**ADDENDUM NO. 1 TO PROJECT NO. 44418**

**CONSTRUCTION WORK AND ELECTRICAL WORK**

**SITE IMPROVEMENTS,  
PURPLE PATH AND INDIAN POND  
STATE UNIVERSITY OF NEW YORK  
1400 WASHINGTON AVENUE  
ALBANY COUNTY, NEW YORK**

April 25, 2012

DWG NO:  
C-1

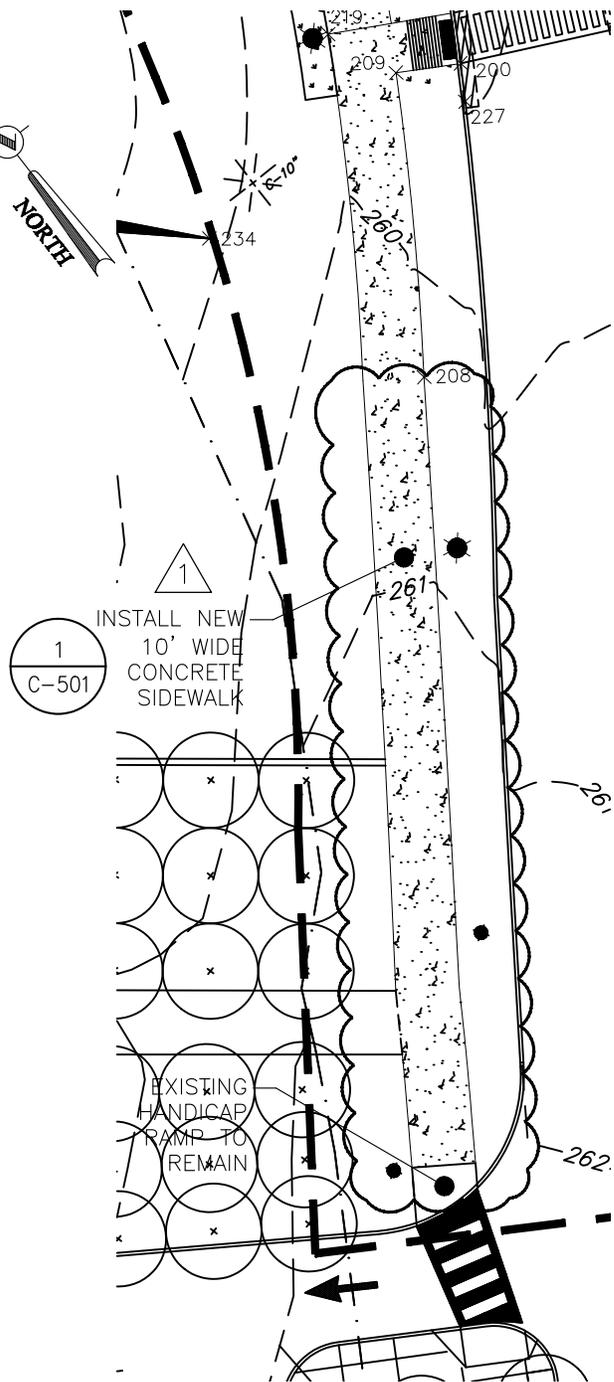
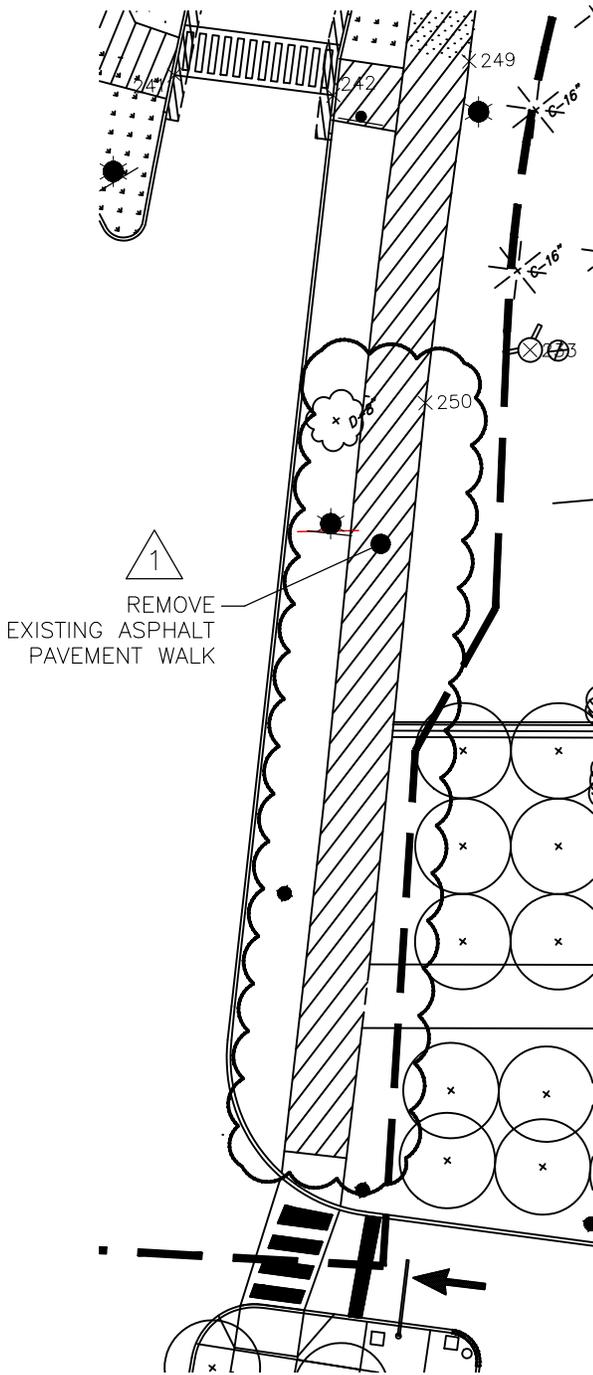
1. Drawing Nos. C-003/C-004
  - a. **Add** Advanced Warning Signage (“Work Zone Ahead” signs per sign schedule) at five locations - west of Phase 2A project limits along University Drive; at Washington Avenue East Entrance to University Drive; south of Phase 3B project limits along University Drive; east of Western Avenue entrance project limits along University Drive; and west of Western Avenue project limits along University Drive.
2. Drawing No. C-101
  - a. **Add** sketch for additional asphalt walk removal per Addendum drawing C-1.
3. Drawing No. C-102
  - a. **Add** sketch for additional asphalt walk removal per Addendum drawing C-2.

1  
C-1 **REMOVAL PLAN**  
SCALE: 1"=30'

2  
C-1 **LAYOUT PLAN**  
SCALE: 1"=30'

SHEET TITLE: REVISED ASPHALT PAVEMENT  
REMOVAL AND NEW CONCRETE  
SIDEWALK EXTENTS

DWG NO:  
C-2

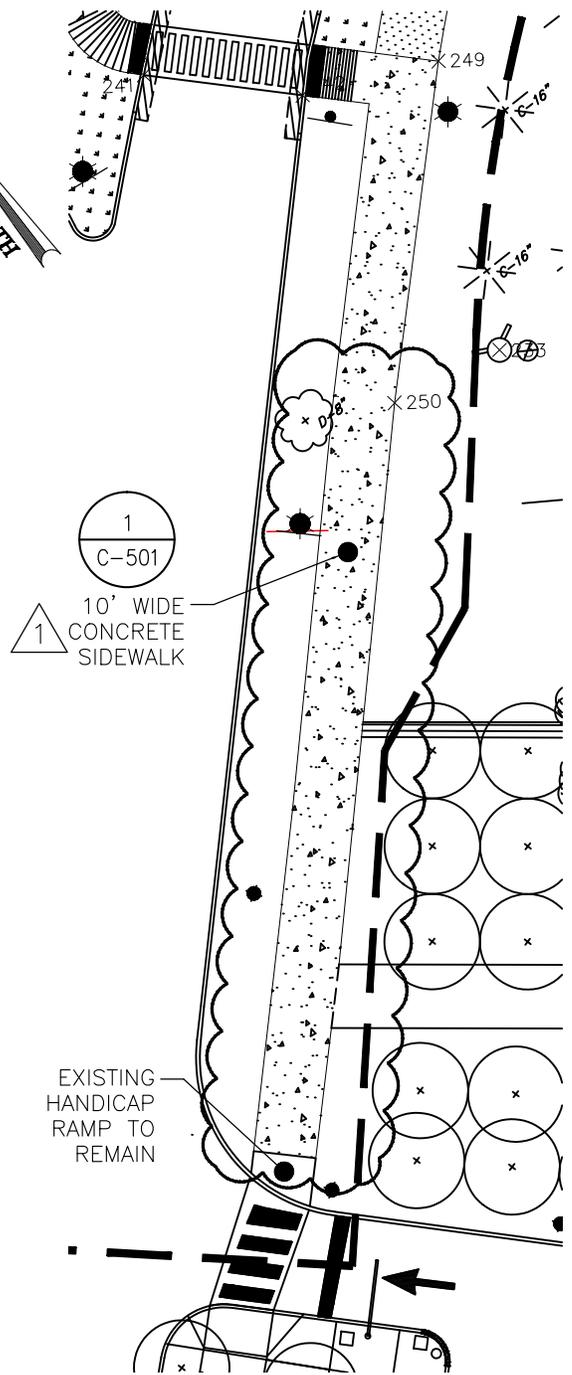
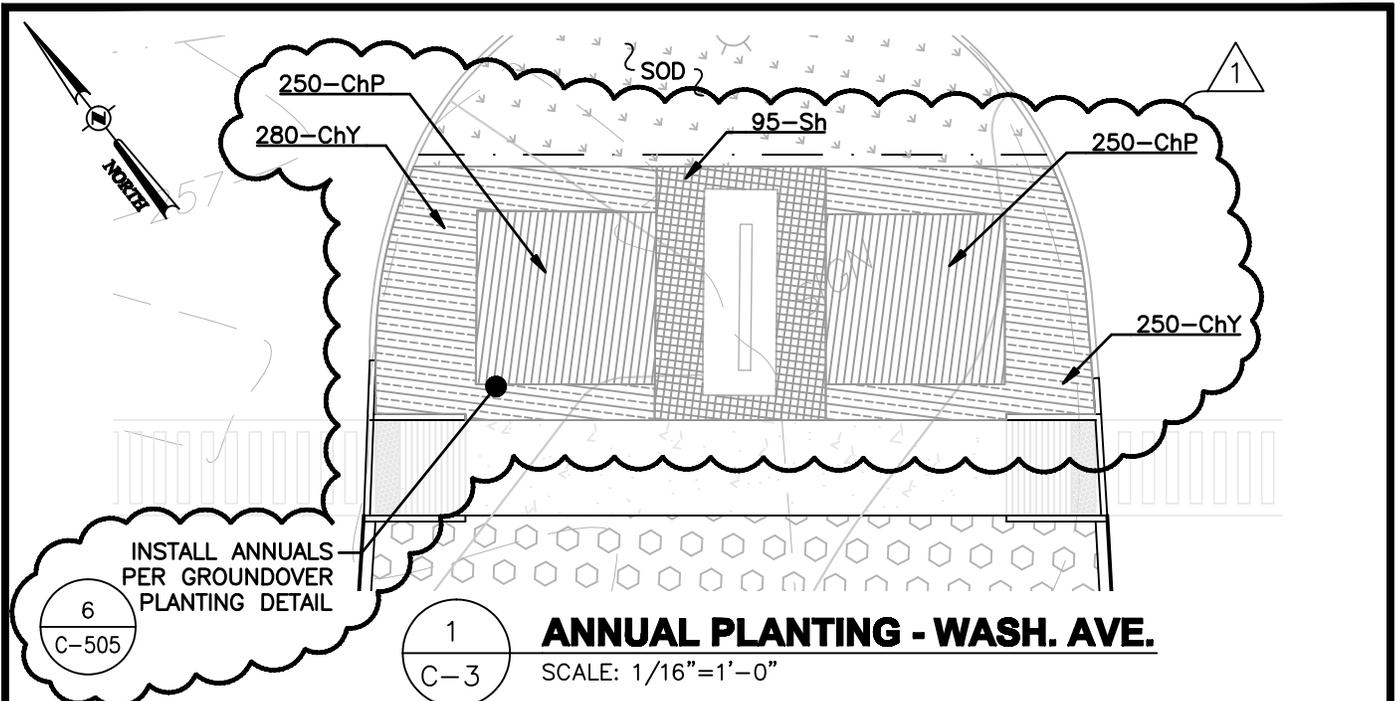
7. Drawing No. C-112
  - a. **Add** sketch for additional concrete walk installation per Addendum drawing C-2.
8. Drawing No. C-115
  - a. **Add** sketch for additional granite curb installation per Addendum drawing C-8.

1  
C-2  
**REMOVAL PLAN**  
SCALE: 1"=30'

2  
C-2  
**LAYOUT PLAN**  
SCALE: 1"=30'

SHEET TITLE: REVISED ASPHALT PAVEMENT  
REMOVAL AND NEW CONCRETE  
SIDEWALK EXTENTS

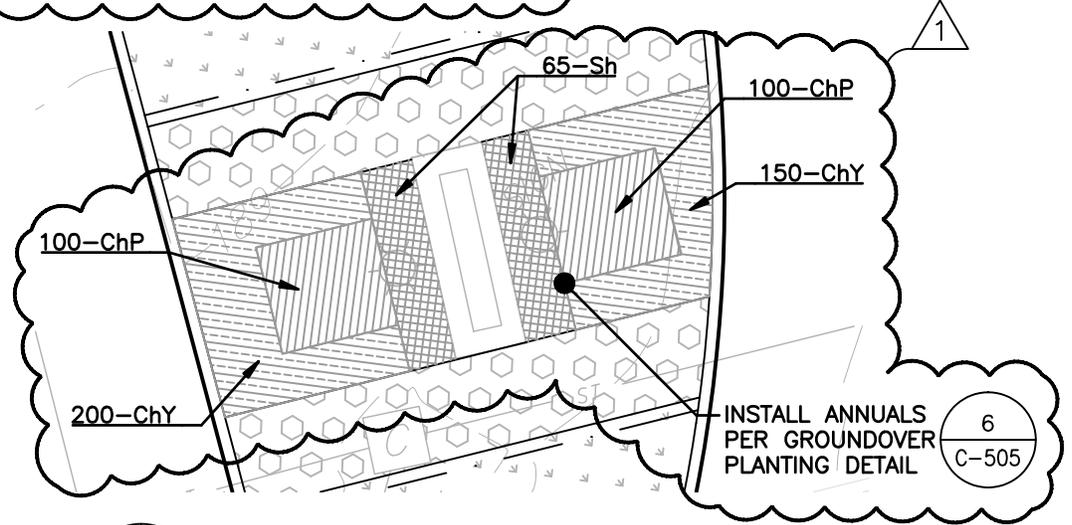
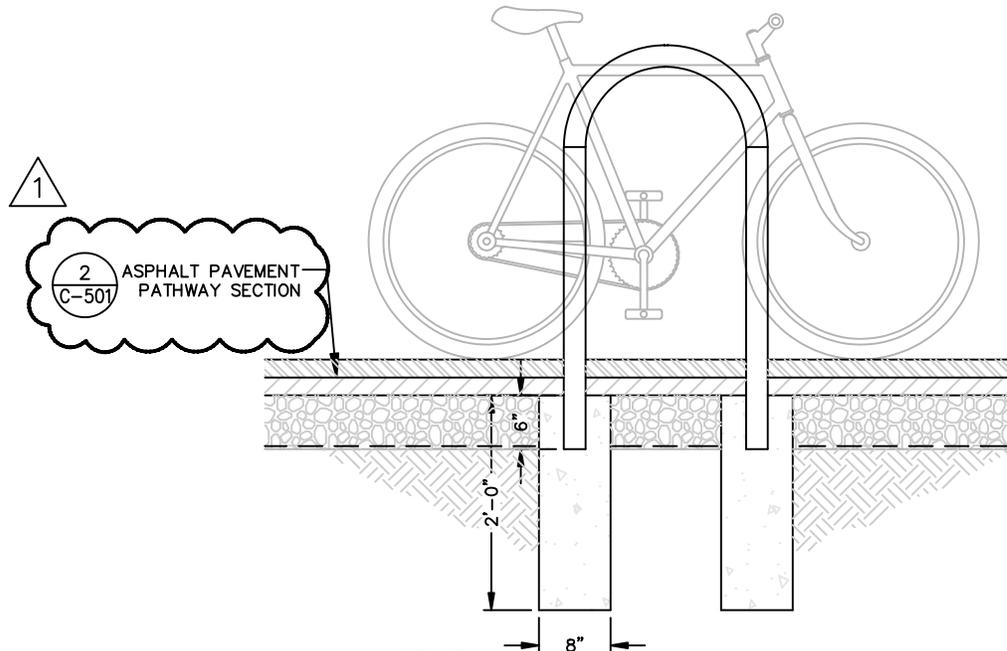
11. Drawing No. C-131
  - a. **Add** sketch for additional annual plantings at Washington Avenue entrance per Addendum drawing C-3.
  - b. **Replace** the Overall Plant List with the revised list on Addendum drawing C-7.

12. Drawing No. C-135
  - a. **Add** sketch for additional annual plantings at Western Avenue Entrance per Addendum drawing C-3.
13. Drawing No. C-138
  - a. **Delete** drawing C-138 in set. **Replace** with revised Addendum drawing C-138.

**1**  
C-3 **ANNUAL PLANTING - WASH. AVE.**  
SCALE: 1/16"=1'-0"

**2**  
C-3 **ANNUAL PLANTING - WESTERN AVE.**  
SCALE: 1/16"=1'-0"

DWG NO:  
 C-4

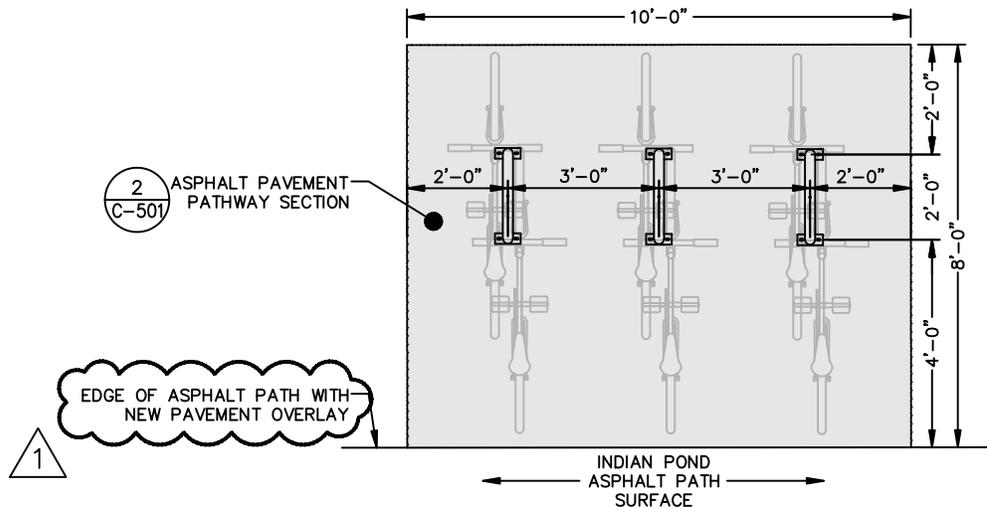
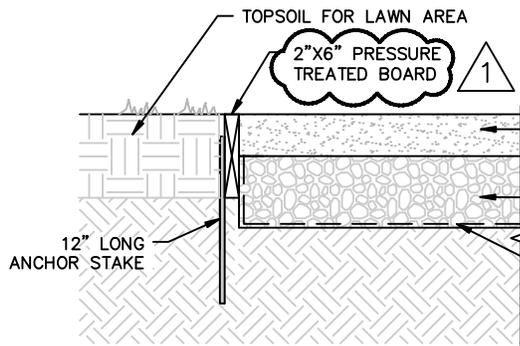
- a. **Replace** detail 5/C-502-Picnic Table Pad Area w/ Wood Edging with revised detail on Addendum drawing C-5.
  - b. **Replace** detail 13/C-502-Bike Rack with revised detail on Addendum drawing C-4.
17. Drawing No. C-503
- a. **Replace** detail 5/C-503-Timber Seating Surface on Gabion Wall with revised detail on Addendum drawing C-6.

13 **BIKE RACK**  
 C-502 SCALE: NOT TO SCALE

SHEET TITLE:  
 REVISED BICK RACK DETAIL
